ECAC WORKING GROUP COMMENTS ON EIS AND HYDROGEOLOGICAL STUDY  
for **735 Southdale Road West**

Received at ECAC's March, 2023 meeting

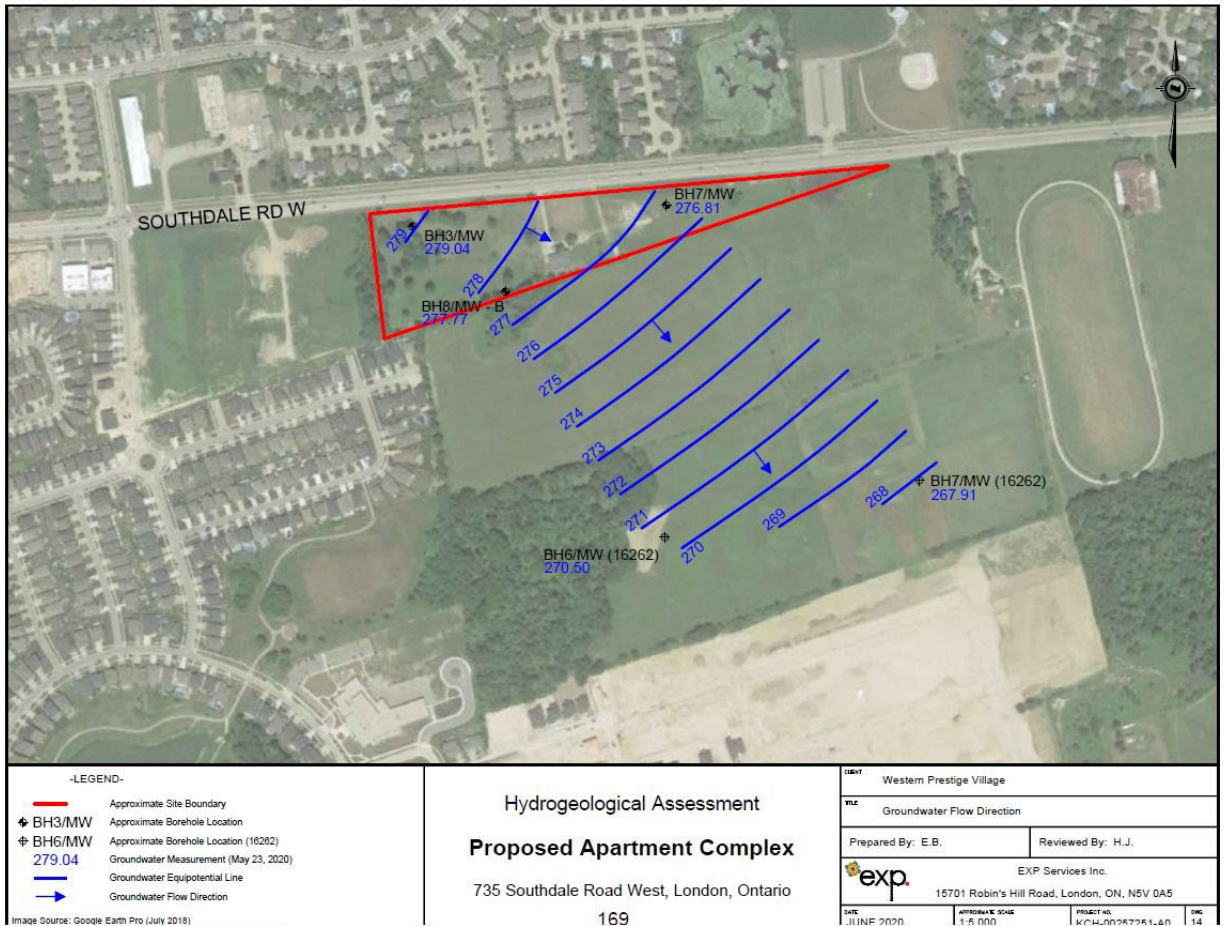
Page 28: It is proposed that runoff from impermeable surfaces (ex: rooftops) and infiltration in landscaped areas will contribute to the North Talbot PSW to maintain appropriate surface water levels post-development (EXP, 2022). ECAC is skeptical that this will provide the appropriate surface water levels. The quality will certainly change as run off from the surface parking lot will contain salts and oils. It is certainly unclear how runoff from the rooftops will be directed to the landscaped areas. Recommendation 24 indicates not even directing rooftop water to the PSW until “after the grounds have been vegetated and stable for housing and development adjacent to vegetation, roof leaders should be directed to the streets or nearby stabilized vegetated areas.” It is also likely that over the long term, the LID measures will not be maintained by the private owner.

Recommendation: Detail design of the LID and other measures to achieve the water balance noted in EXP must be to the satisfaction of the City and UTRCA Hydrologists.
